# LBHA Airspace Change Proposal ACP-2018-69

Options Development & Design Principles Evaluation

Date: 1st March 2023  
Revision: Issue 1.1  
Osprey Ref: 71311 011

Figure 15 – Runway 03 North 3

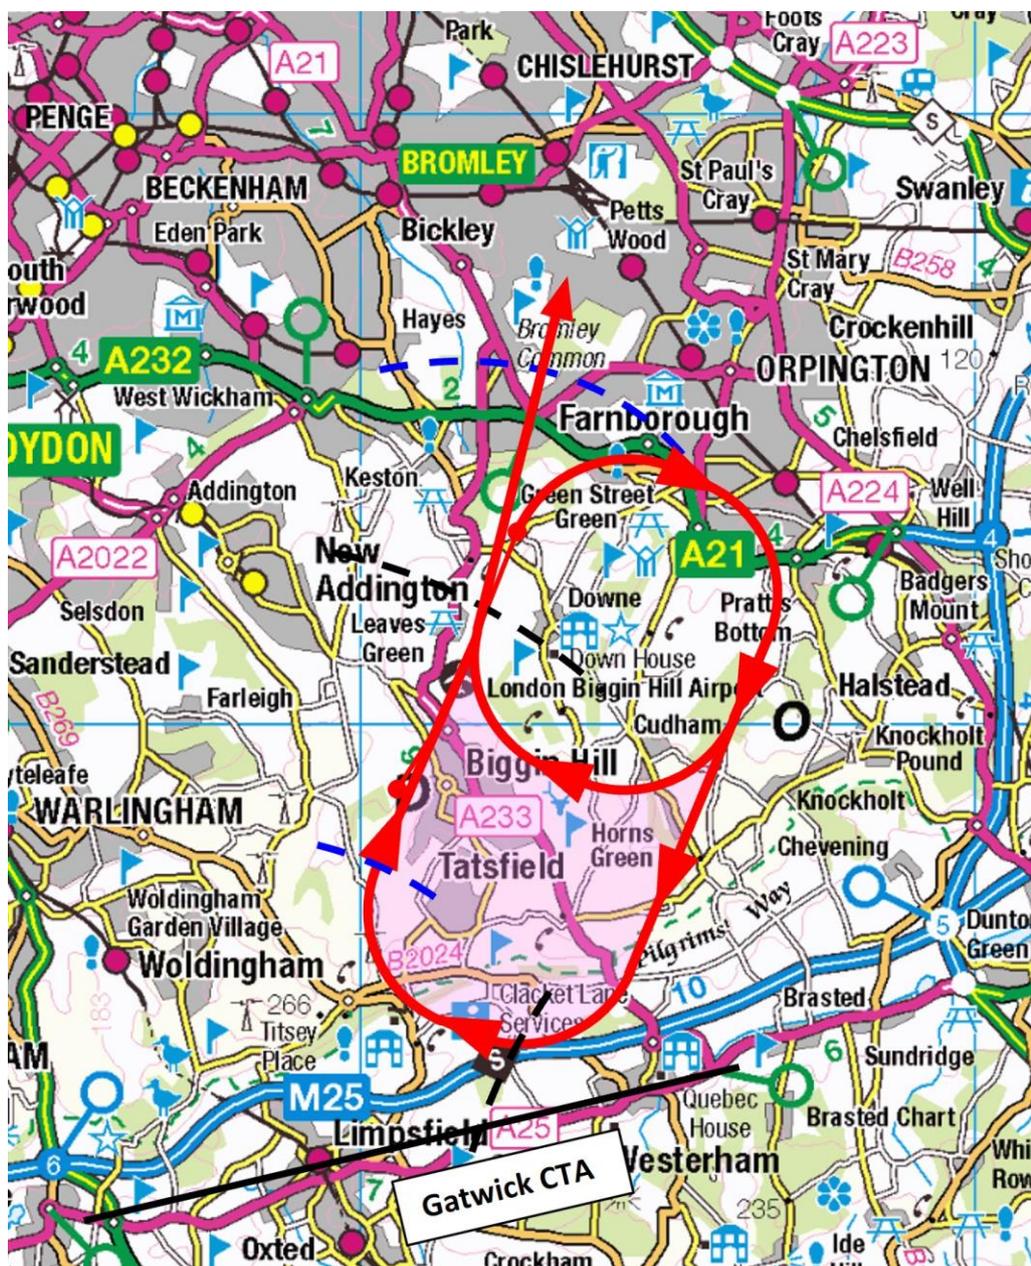
Individual	I am a Knockholt resident and I strongly oppose the right hand flight path which is 10b.	
Individual	Of the 2 suggestions for the South Airspace Change we prefer option 10a 03 North LH	
Individual	Biggin Hill Airport is part of the Bromley Borough and the newly proposed route for aircraft at Biggin Hill should therefore use the airspace over Bromley and not over the Sevenoaks District. Therefore route option 10a, with a Left Hand (LH) turn off runway 03, then back through Biggin Hill overhead proceeding North should be utilised rather than route 10b	
Individual	10a. 03 North LH appears to be less densely populated and therefore sound and air pollution would impact on fewer residents and so is our preferred option.	
Individual	I would like to state my preference for the proposed changes to be 10a. 03 North LH	
Individual	I would like to make my opinion on the preferred flight path from the airport which is 10a . 03 North LH.

Runway 03 departure to the north were introduced that turned south initially (left turn and right turn after take-off) before circling back over the airport to route north. These were included as options 10a and 10b and were subsequently shared with stakeholders.
Focus Group	Concern that the higher climb rates would create more noise on the ground.	Currently aircraft have to level at 2,400 ft before getting clearance to climb further. The aim of these options is for unconstrained climbs to 7,000 ft. The noise impacts will be modelled in more detail as we get closer to consultation. The type of aircraft that operate from Biggin Hill are lighter and had smaller engines and are much quieter than airliners. The noise impacts will be modelled in more detail at the next stage of the CAP 1616 process.
Focus Group	When aircraft currently take off and circle to route over the centre of the airfield the impact is much less. Some departing aircraft end up further north than the airfield boundary and this has a bigger impact. They stated that it would be helpful if any route options that circle back to pass over the airfield use the middle of the runway as a reference point.	This will be considered as the options develop.

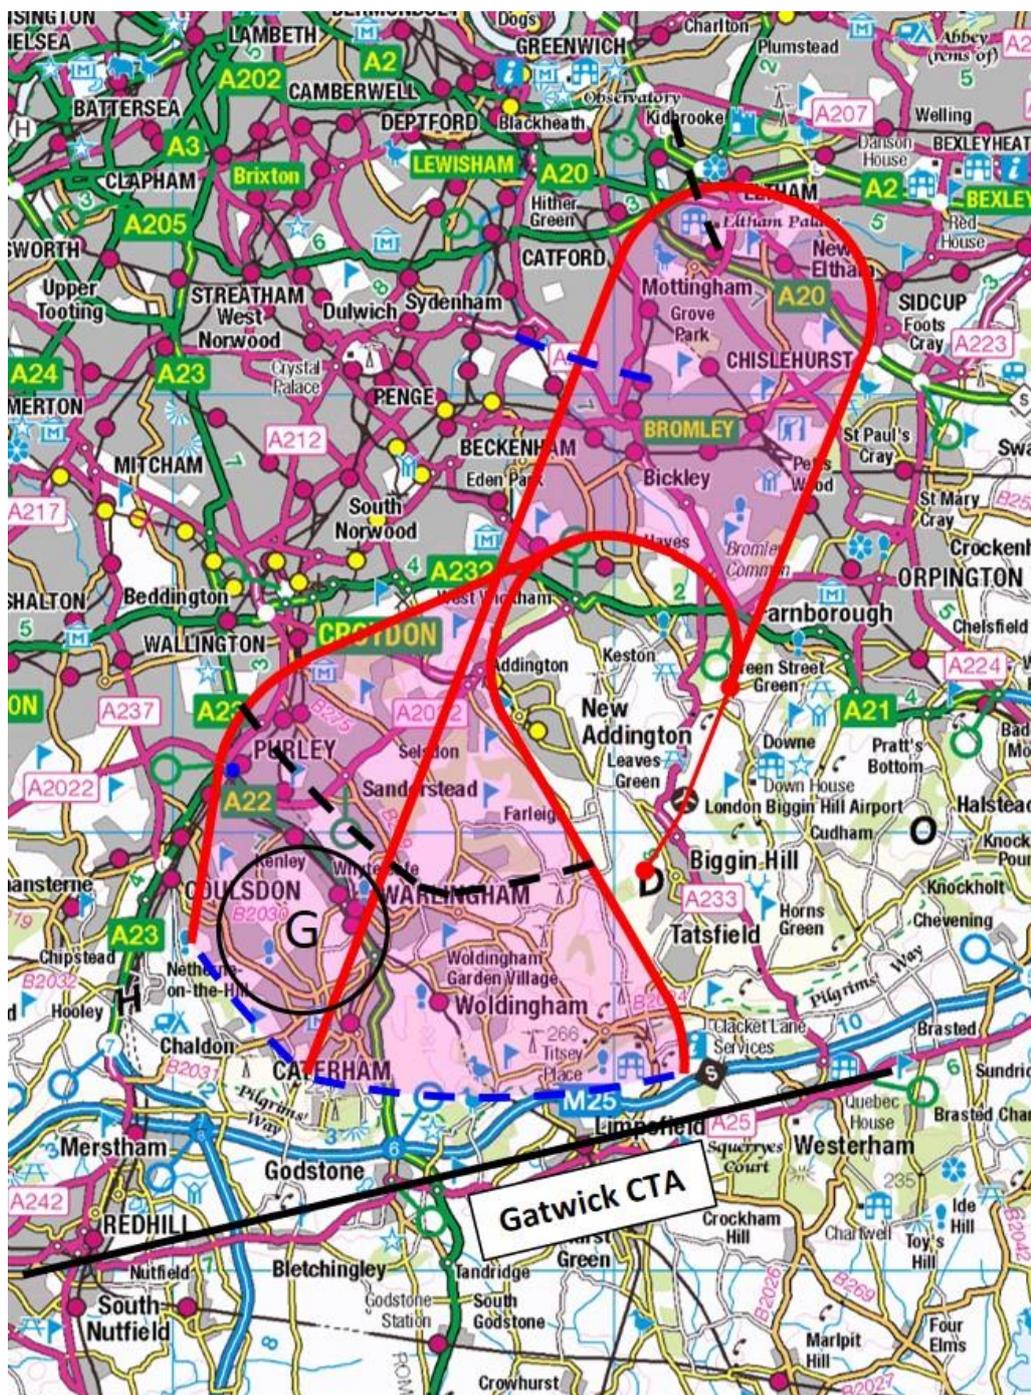
<p>Of the Options proposed, it is considered that D12 and D17 would have the least impact on the two AONBs and are therefore the AONB Units preferred options.</p> <p>Minor adjustments through small scale tightening of the indicated swathes of Options D7, D8, D10, D15 and D16, would also result in no overflying of the AONBs.</p> <p>Options D4, D5 and D14 would have the most impact on the two AONBs and are not therefore supported.</p> <p><b>Arrival Options:</b></p> <p>The existing arrival route largely avoids overflight of the Kent Downs AONB. Any change that results in overflying of the AONB would not meet the Design Principle of avoiding overflying sensitive areas and would not be supported by the AONB Unit.</p> <p>Option A1 and A4 both avoid no overflying of the Kent Downs AONB and are therefore supported.</p> <p>Option A3 would result in overflying of a relatively small section of the Kent Downs and Surry Hills AONBs which, given the current baseline situation, should be avoided if possible.</p> <p>Option A2 however introduces overflying of a large swathe of the Kent Downs AONB, which would be wholly opposed by the Kent Downs AONB Unit.</p>

Figure 20 – Runway 03 West 1

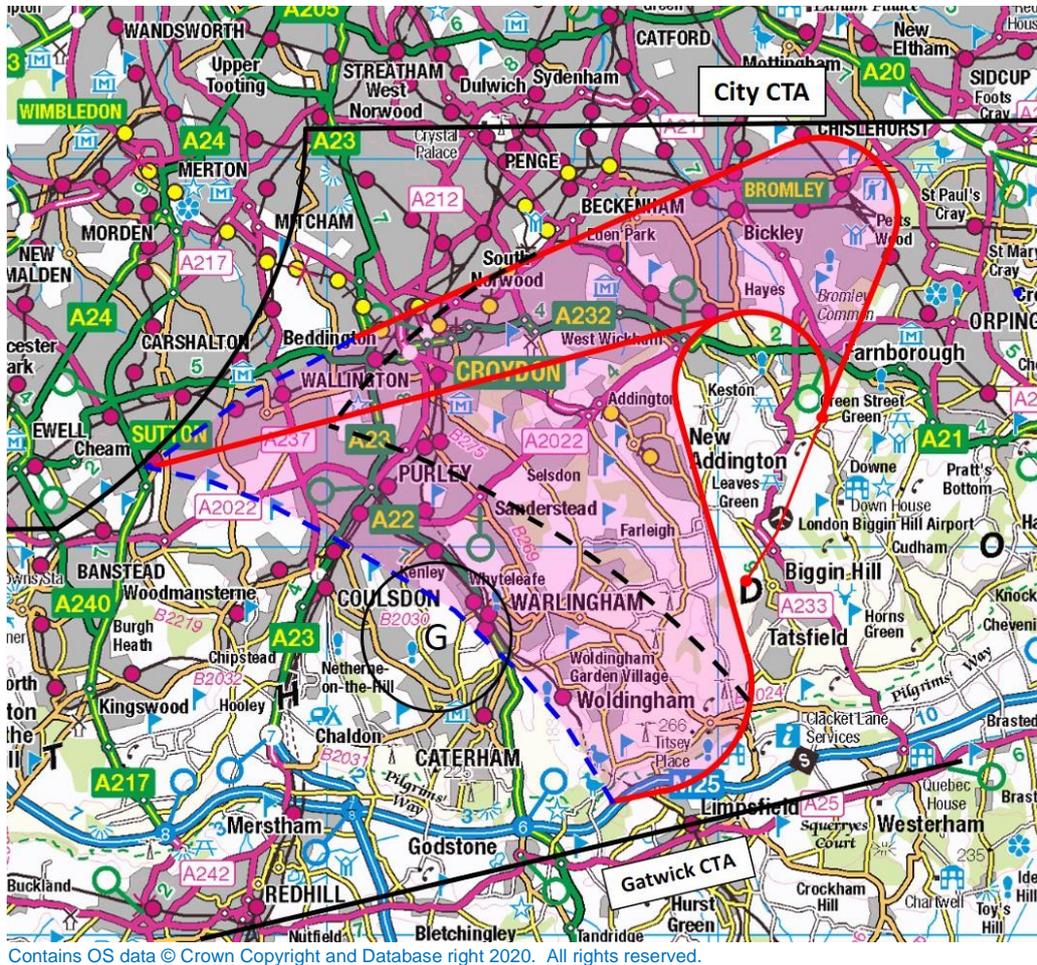
<p>19. RUNWAY 03 – DEPARTURE WEST 1 – OPTION D 15 - Unacceptable. Far too great a swathe to the west overflying populations not already overflown.</p> <p>20. RUNWAY 03 – DEPARTURE WEST 2 – OPTION D 16 – Noted</p> <p>21. RUNWAY 03 – DEPARTURE WEST 3 – OPTION D 17 - Unacceptable. Far too great a population currently not overflown. Would appear to conflict with aircraft landing from the north and using the ILS.</p> <p>2. Are there any other route options we should consider that have not already been introduced?</p> <p>I think you should have shown the detail with commentary about how the 03 GPS arrival route is currently drawn. This is needed to provide contributors with further information of potential flight’s overhead.</p>	
London City	<ul style="list-style-type: none"> <li>• Any departures that track north, or arrivals from the north, increase interactions with London City traffic and may therefore impact both airports due to the airspace constraints in that area.</li> <li>• Given both airports’ aspirations for growth, gaining freeflow for both airports should be a priority. Deconfliction of routes to the north would therefore be required to avoid interdependency.</li> <li>• We support the desire to move away from shared arrival structures as these result in capacity constraints for either or both of our airports. With Biggin's growth, we are seeing this impact today, particularly in periods of non-standard operations such as poor weather.</li> <li>• We draw attention to the dimensions of our CTA/CTR. There is no safe procedural method for Biggin traffic to enter this airspace.</li> </ul>	<p>LBHA acknowledges the likelihood of interactions with London City traffic for any new routes to the north. We will continue to work closely with London City Airport to ensure routes are deconflicted through the FASI-S programme.</p>
